Reference : CHANGE NOTICE No. MB/09/07

Subject : Change in mdi Closed Sterility Test Device Stericheck (All types)

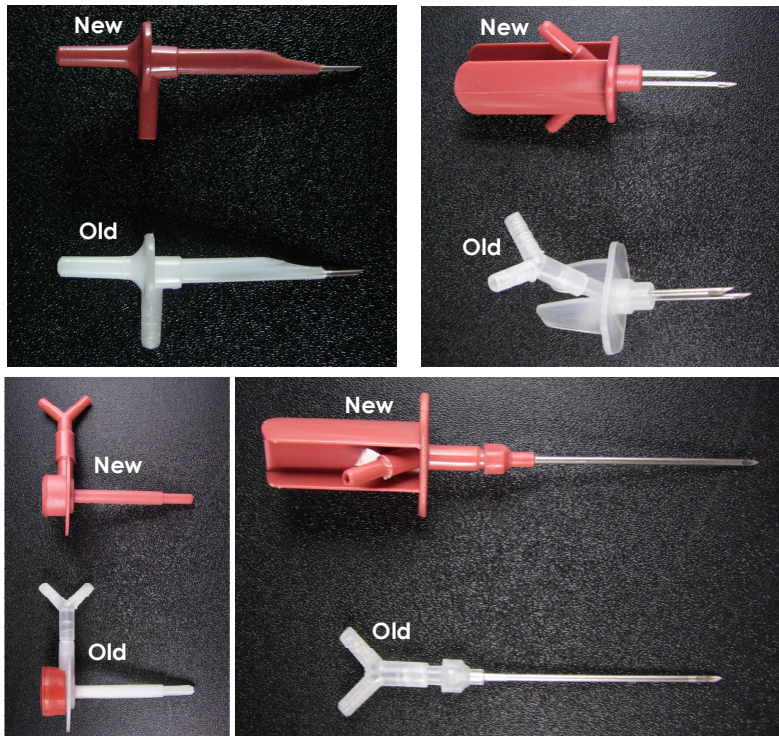
- Needles - Improved thermal performance with better grip

- **Needle:** The plastic polymer used now can withstand higher temperature and the needle design was improved for better grip.
